The City of Spartanburg Design Review Board

1. DRB-26-020-00001 — The Design Review Board (DRB) has received a request for Preliminary Conceptual Approval of the proposed development, Converse Street Apartments, located at 120 E Kennedy St (Tax Map Sheet: 7-12-06-061.00) with a zoning designation of D-T6, Downtown Urban Core.

PROJECT/ADDRESS/ TAX IDConverse Street Apartments / 120 Kennedy St /
7-12-21-103.00**PROJECT NUMBER**

REVIEW STATUS – Preliminary Review**COPIES TO**

L100

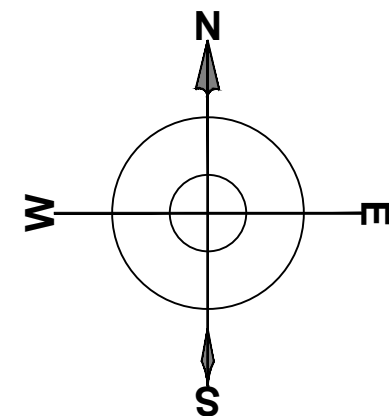
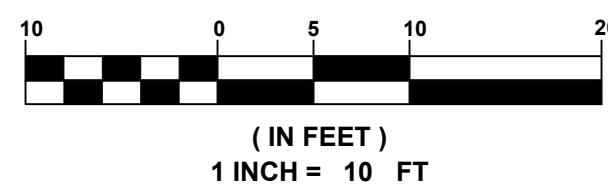
- **8.1 Required Streetscape:**
 - D-T6: 16 ft zone with 16 ft wide sidewalk and trees in wells: *Exception Required – Proposed 11 ft average streetscape on Kennedy Street with 4x6 ft tree wells. Sidewalk to be installed to face of building with minimum 6 ft width. Proposed 12 ft average streetscape on Converse Street with 4x6 ft tree wells. Sidewalks to be installed to face of building with minimum 7 ft width.*
- **8.2 Parking Area Landscaping:** *Not Applicable*
- **8.3 Streetscreens:** *Not Applicable*
- **8.4 Fences:** *Not Applicable*

- Streetscape (16' w/ tree wells) – Currently there is only +/-10' from the property line (R/W) to the back of curb on Kennedy Street and +/-11.5' from property line (R/W) on Converse Street. The entire 10' on Kennedy St. is currently sidewalk. There is a 7.5' wide sidewalk on Kennedy Street.

- Proposed +/-11' average streetscape (10' at narrowest) with 4'x6' tree wells to separate pedestrian traffic from the road. Sidewalk will be installed to face of building with minimum of 6' width.

- Proposed +/- 12' average streetscape (11.5' at narrowest) on Converse Street. With 4'x6' tree wells to separate pedestrian traffic from the road. Sidewalk will be installed to face of building with minimum of 7' width.
